| COA # 2010-COA-165 (HMP) | INDIANAPOLIS HISTORIC PRESERVATION COMMISSION STAFF REPORT | Hearing Date AUG. 4, 2010 |
| 1819 N. Alabama St. HERRON MORTON PLACE | | <i>Continued from:</i> June 2, 2010 July 7, 2010 |
| IHPC COA: 2010-COA-165 (HMP) | Retain siding, windows and trim installed in violation of previously issued COA's. | |

Front/West Elevation

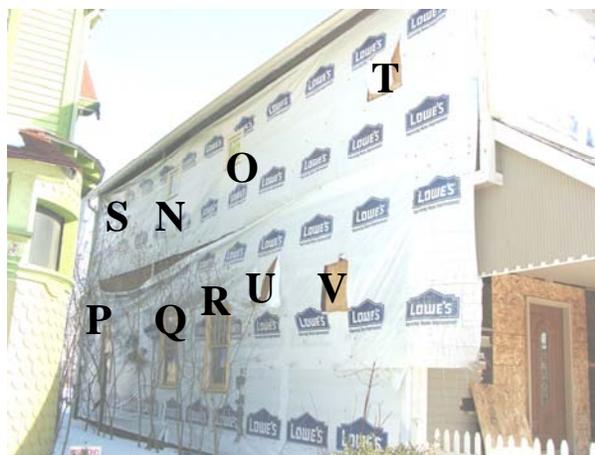
1. **Replacement windows** (Windows A thru R in photos below)– Replacement windows were installed in these openings in violation of stipulations included in COA 08-404 (HMP). The owner had told staff on October 21, 2008, that he intended to repair all existing windows and not replace any windows. All windows were replaced without staff’s agreement that the existing windows were beyond repair and without staff’s sign off on specification sheets for the proposed new window units. Additionally, the replacement windows do not match the dimension, configuration or profile of the original windows.

2. **Original window openings sided over without approval.** (Windows S, T, U, V in photos below)
3. **Siding** on all elevations was removed and replaced in violation of stipulations included in COA 08-404 (HMP). The applicant did not submit photos of the areas where siding was to be replaced as required by the COA or get staff’s agreement that the siding was beyond repair. The applicant installed all new siding that does not match the dimension of the original siding (*now 6 inches/originally 5 inches*).

4. **Trim around all windows** was removed and replaced in violation of stipulations included in COA 08-404 (HMP). All of the new trim is diminished in dimension and profile from the original.

To deny a Certificate of Appropriateness to retain the siding, replacement double hung windows and all trim that was installed without approval and in violation of previously issued Certificates of Appropriateness.
